# ADDENDUM NO. 3

**February 4, 2022**

**Carmel High School Natatorium  
520 Est Main Street  
Carmel, IN, 46032**

This Addendum consists of Pages ADD 3-1 through ADD 3-4, and attached drawing sheet A8S.01 for scope clarification on concrete responsibility break between Bid Category #1 and Bid Category #11

# S3.05

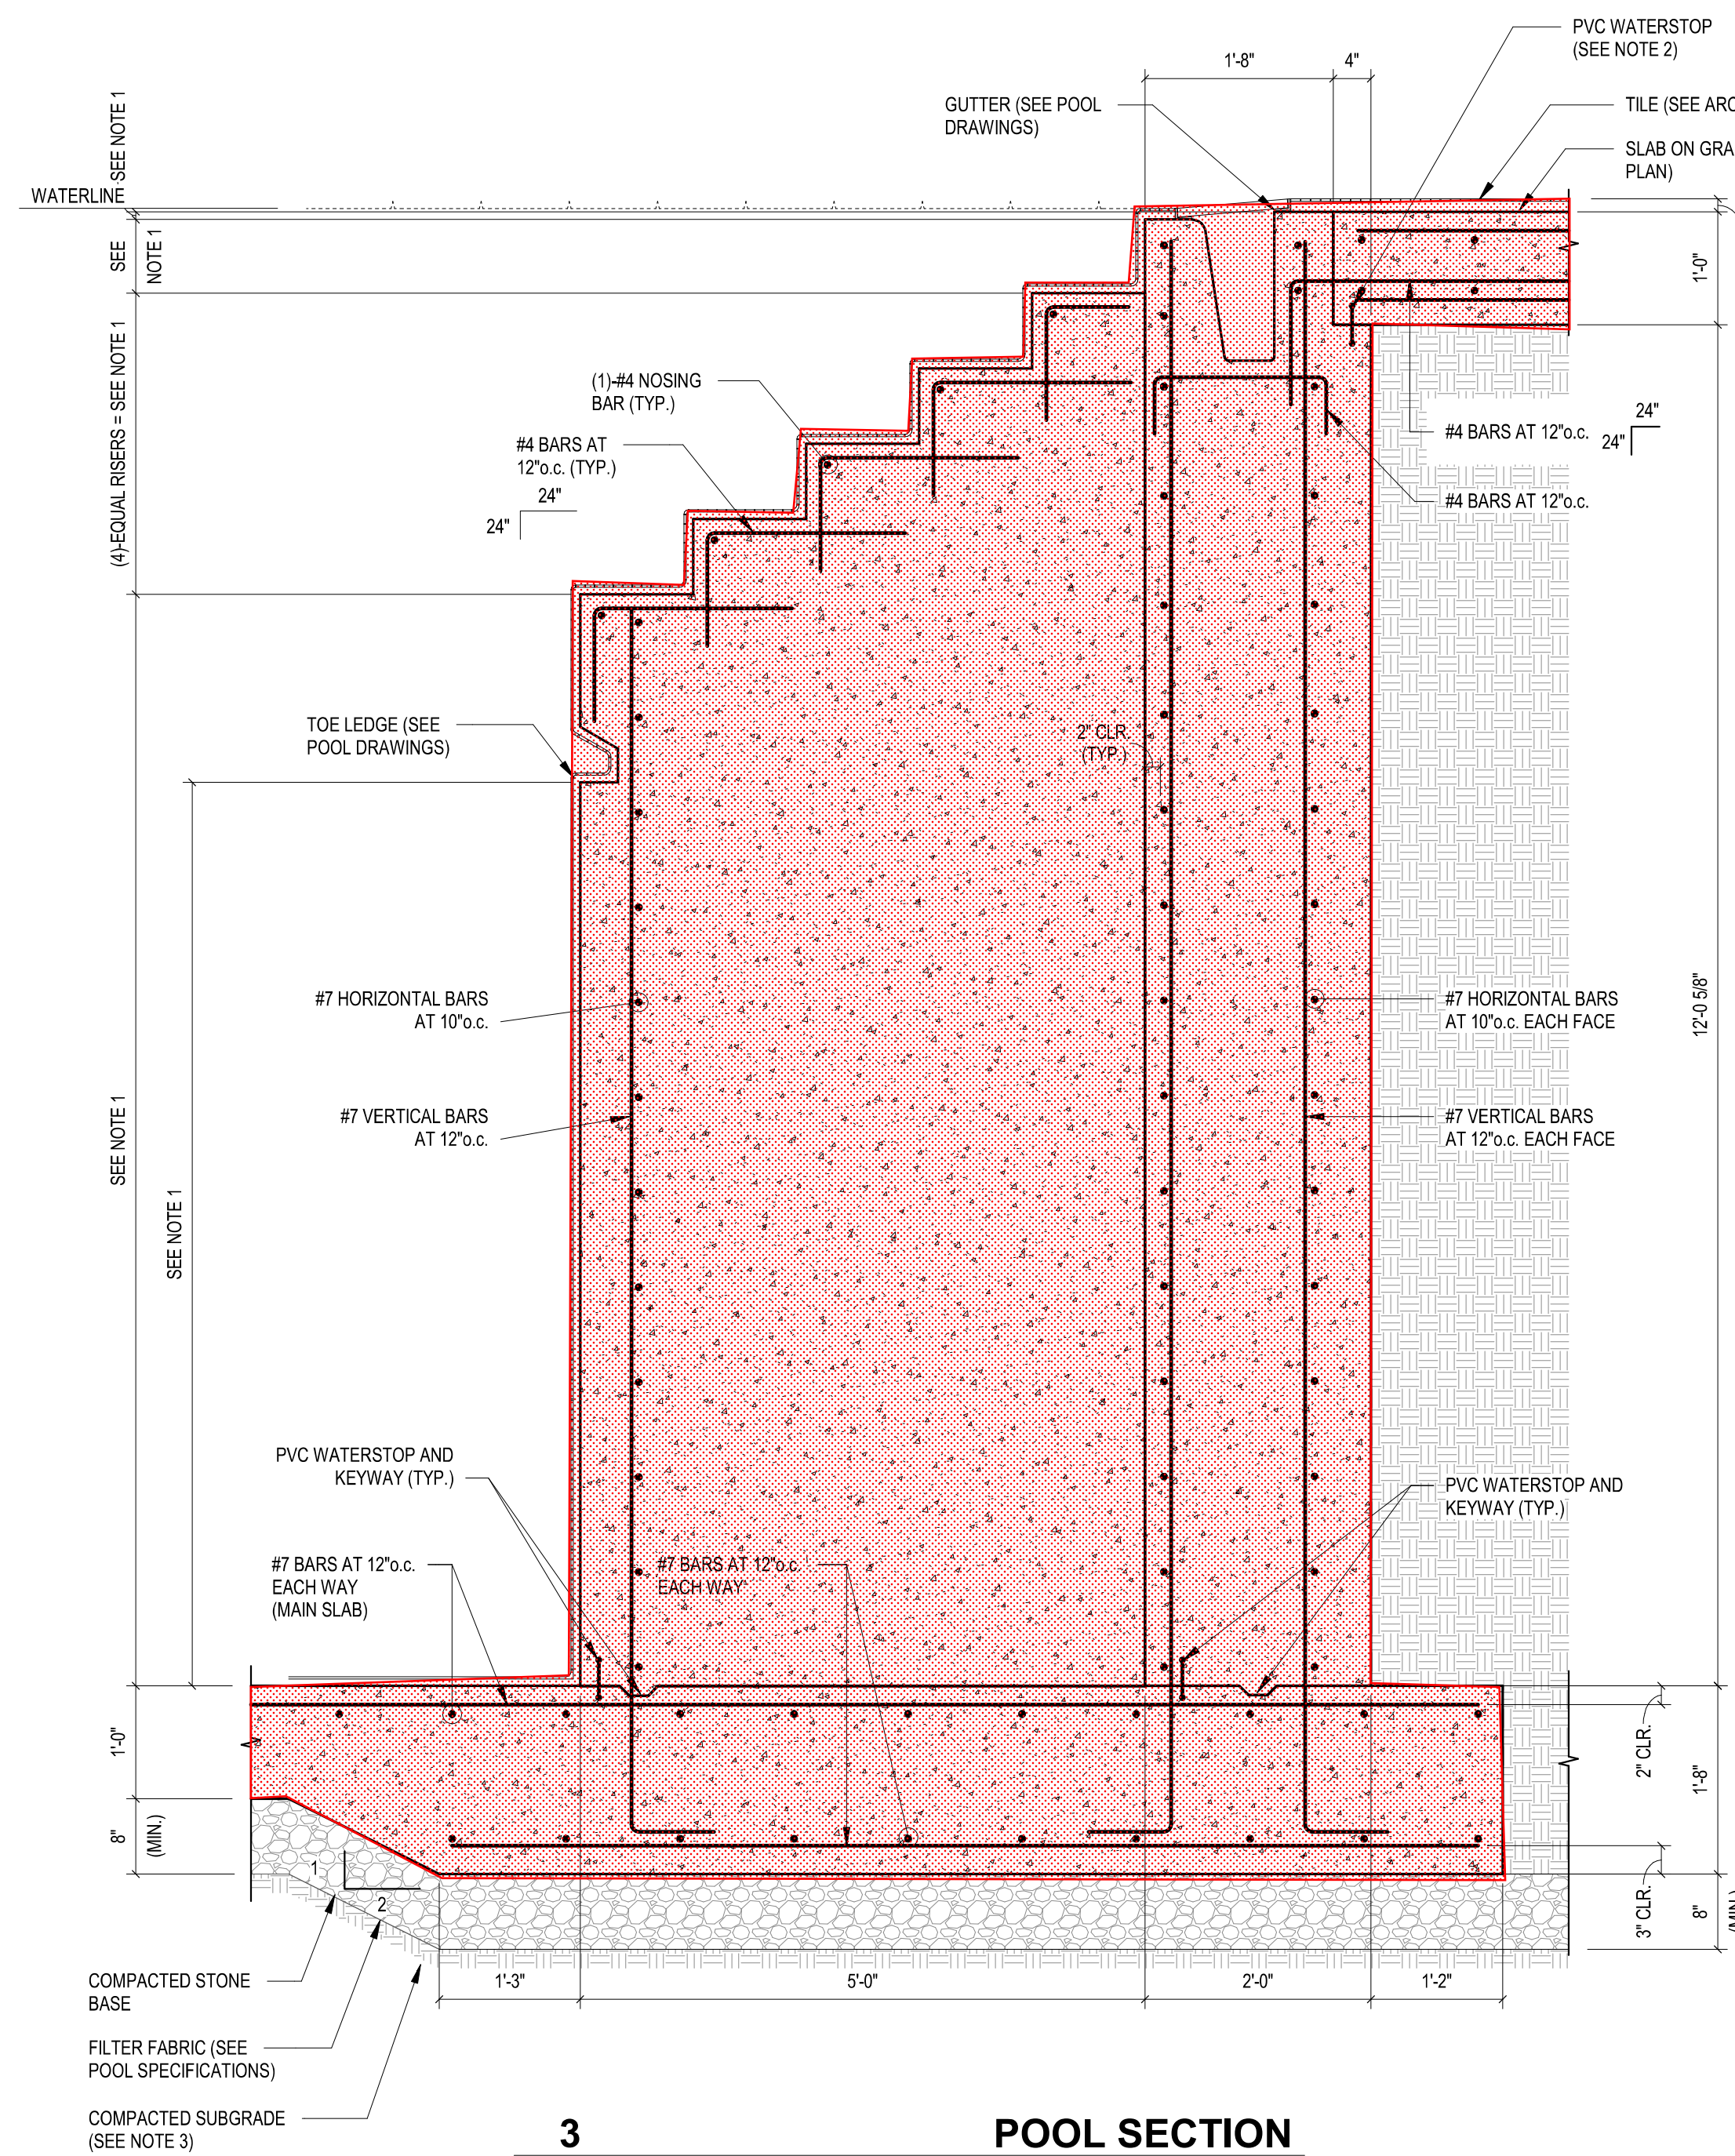
See attached sheet S3.05 Shaded to further clarify the Bid Category 11 Concrete responsibility including the pool base, sides, and deck as shown in the section view attached.

See attached sheet S3.05 Shaded to further clarify the Bid Category 11 Concrete responsibility including the pool base, sides, and deck as shown in the section view attached.

**ADDENDUM #01 (01/25/2022) CLARIFICATION:**  
**POOL SECTION NOTES:** Add "COORDINATE OVERALL CONCRETE DIMENSIONS WITH THE TILE FINISH AND SETTING BED TO ENSURE CORRECT FINISHED FACE OF TILE DIMENSIONS" to Note 1.
